TECHNICAL DRAINAGE STUDY
ADDENDUM #2

Skye Canyon Infrastructure Phase 3A
City of Las Vegas, Nevada

Subject: Addendum No.2 to the Technical Drainage Study for Skye Canyon Infrastructure Phase 3A (CLV DS4931)

EXHIBIT G
SHEET 1 OF 1

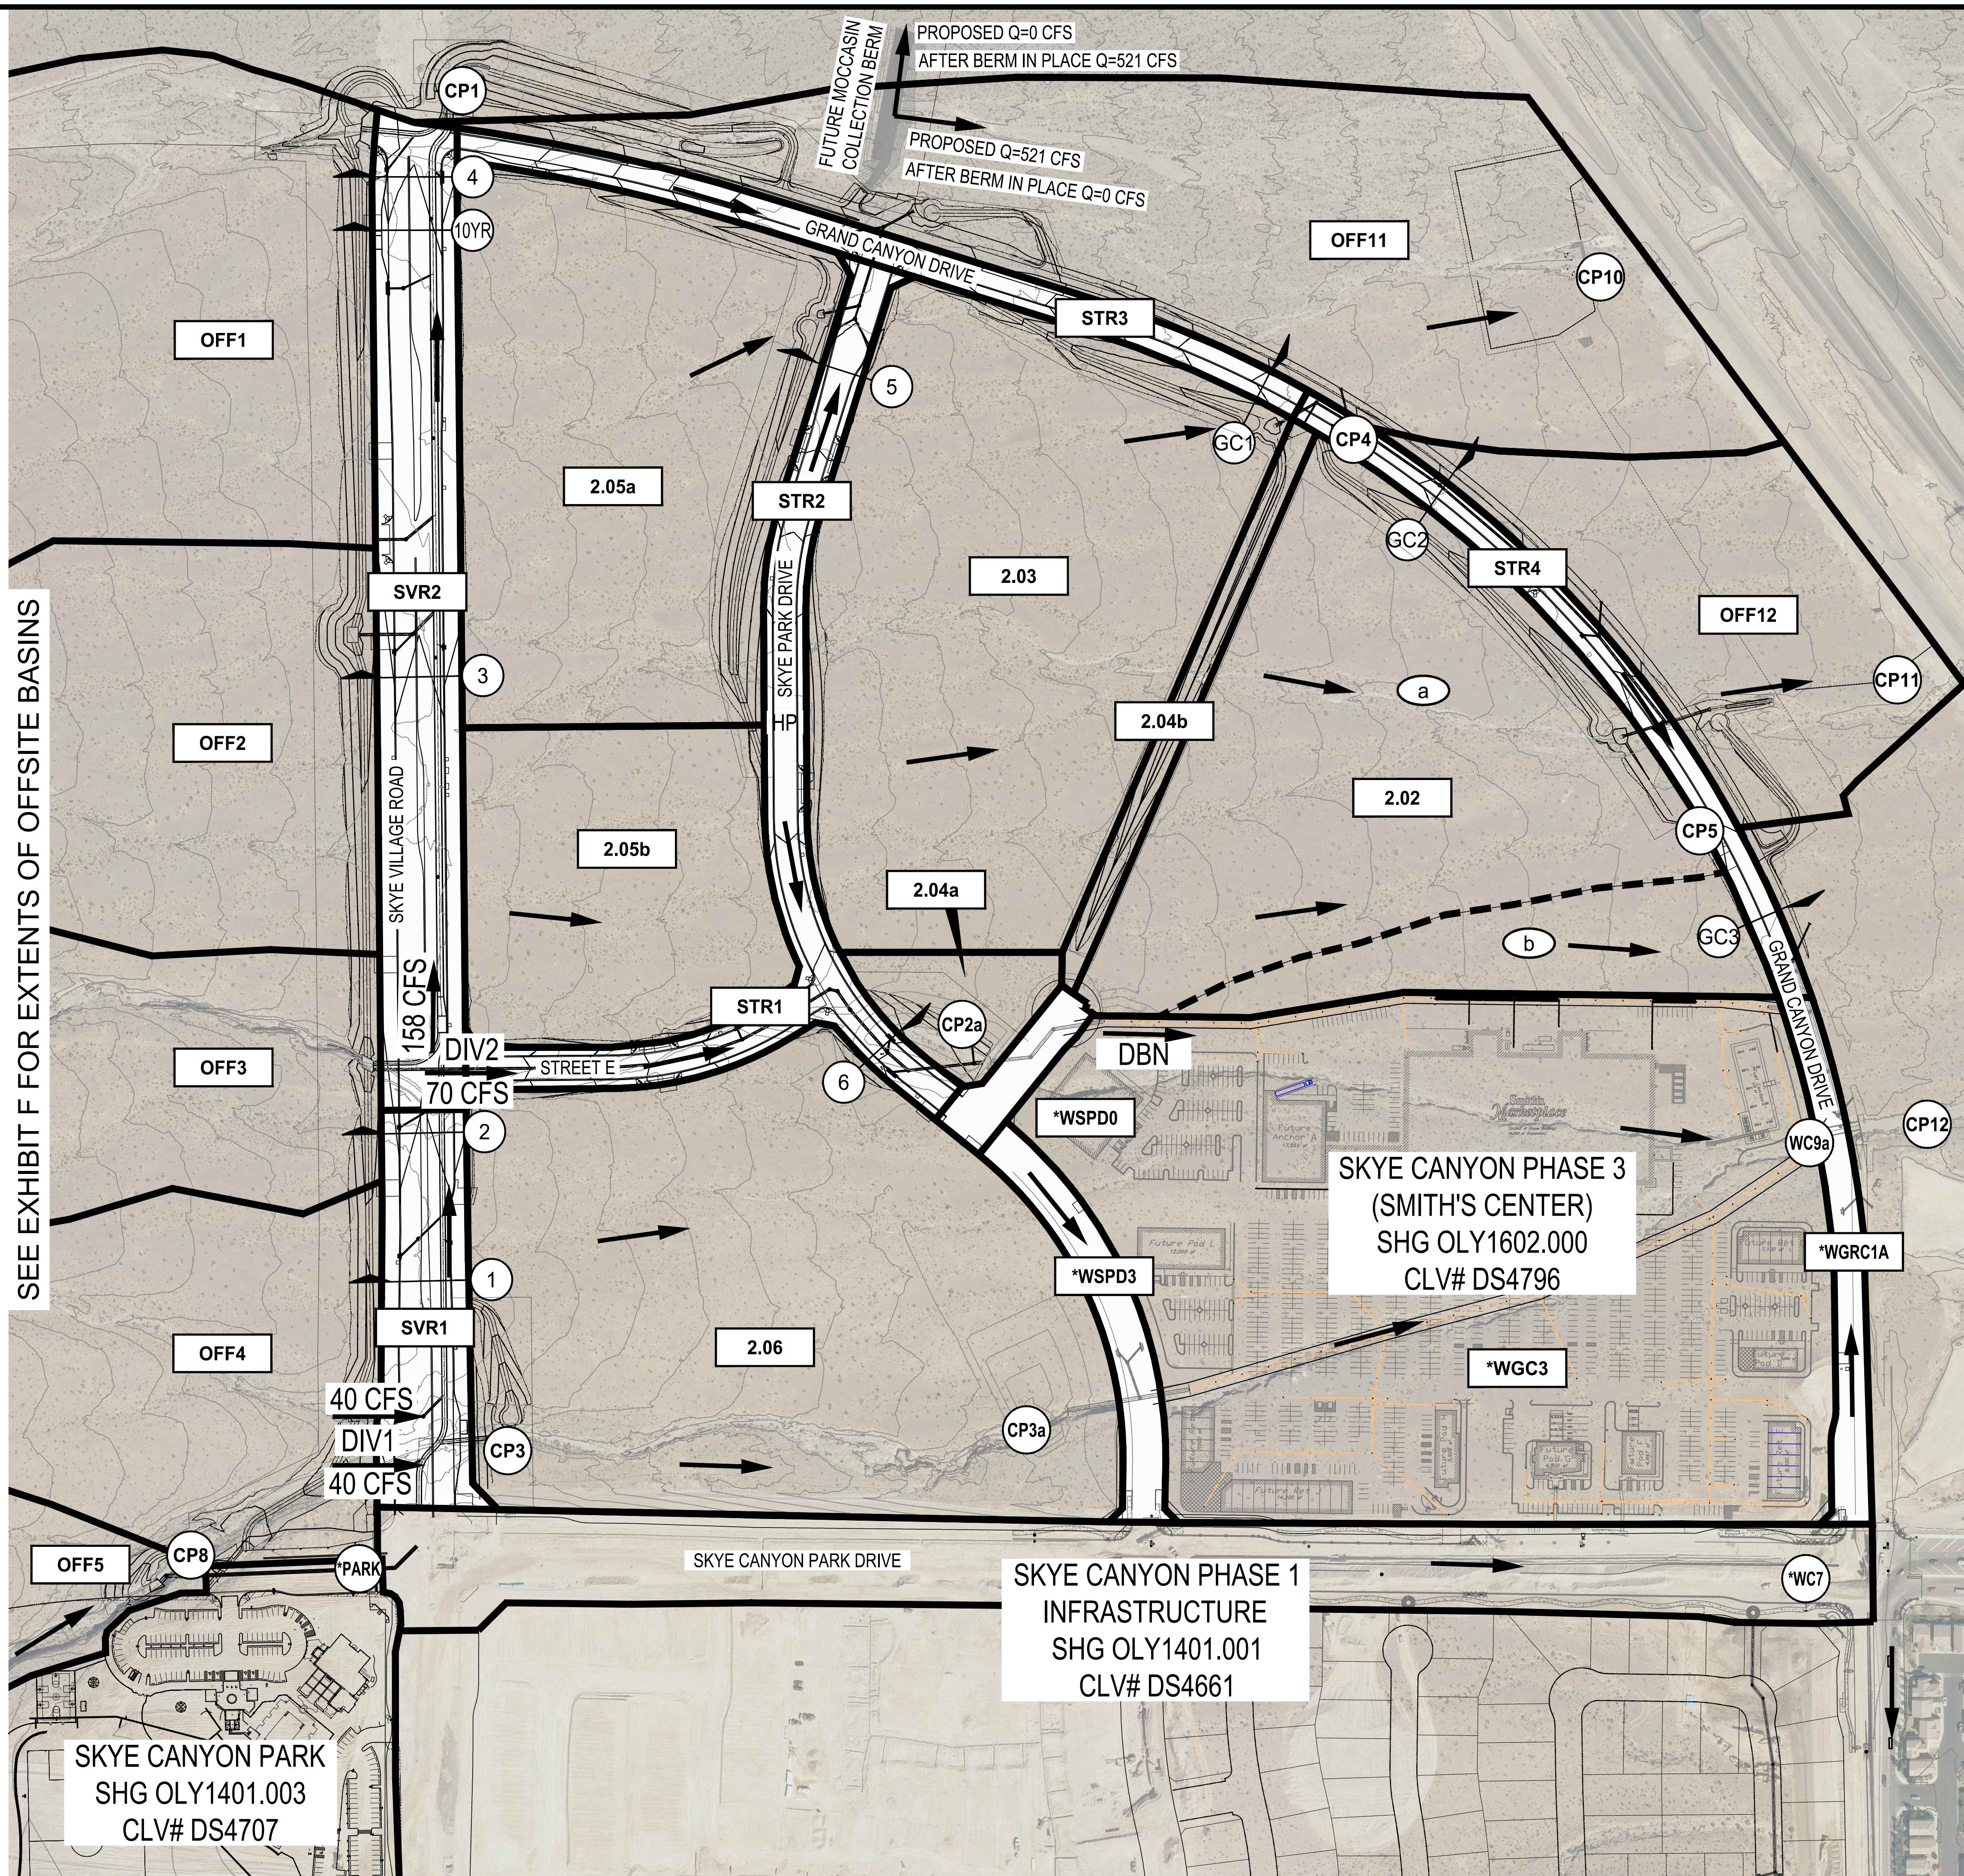
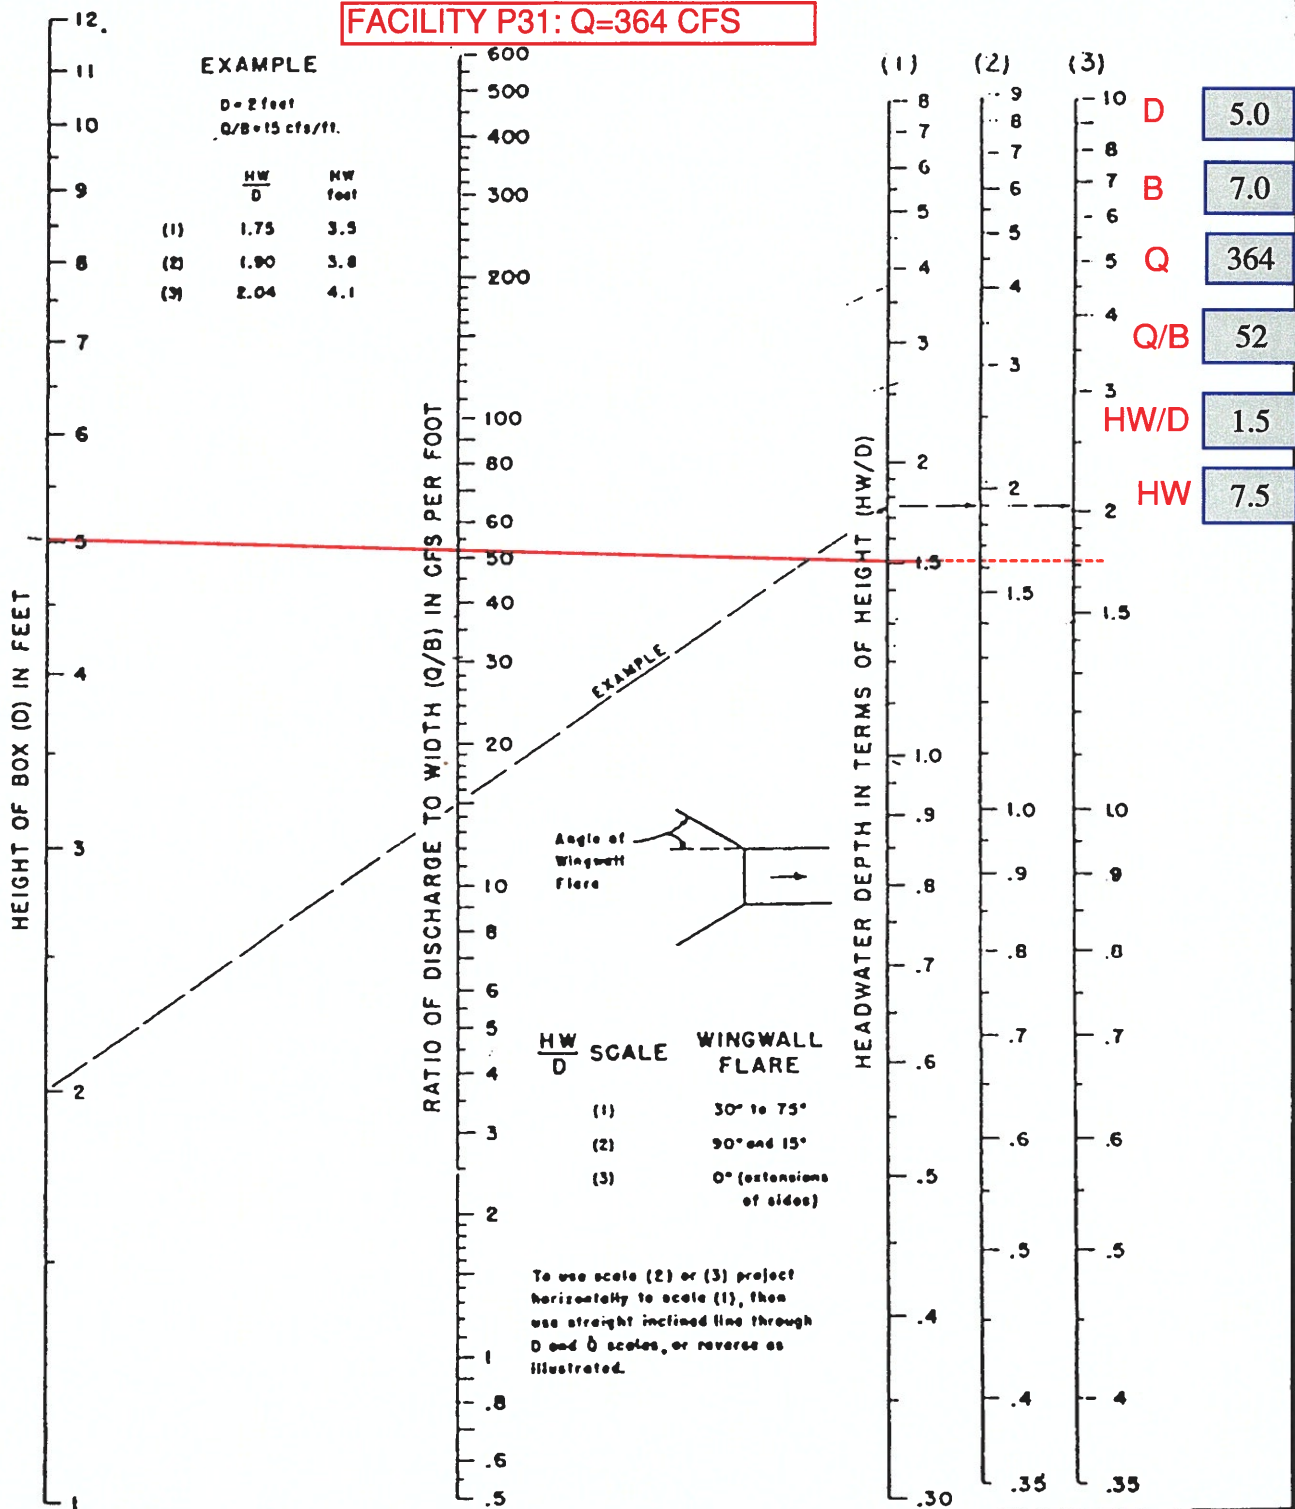
5. **Comment:** *Revise the Phase 3A Exhibits I & G to reflect the proposed interim MPU facility interception Berm/Levee shown on the Moccasin Rd. CCRFCD Flood Control Facility — US95/Kyle Canyon Rd Interchange to Moccasin Rd. (Skye Canyon Developer Funded) plans. Show the connection between the Grand Canyon improvements and this facility design. Provide access road and gate to the berm/levee improvements. Coordinate design between these two facilities.*

17. **Comment:** *Exhibit G: "DIV1" incorrectly shows only 40 cfs. Per "CP3" and "Facility P15", the flow is 422 cfs. Review and revise accordingly.*

Response: Exhibit I is revised to show interim Moccasin Berm facility, see Appendix B. Exhibit G is also revised to show facility, and flow arrows/text are added to clarify that once berm is constructed, all flow at this location will be routed north to the Moccasin Facility. Access road and gate are provided, see Sheet D-04.

Response: DIV1 represents 40 cfs entering the MPU facility at this location via a lateral from the west. The majority of mainline flow at this location comes from the south in a 60" RCP/ 8'x5' RCB conveying flow from CP8 (366 cfs) and PARK (36 cfs). The combination of these flows is the mainline flow at this location (CP3) of 422 cfs.
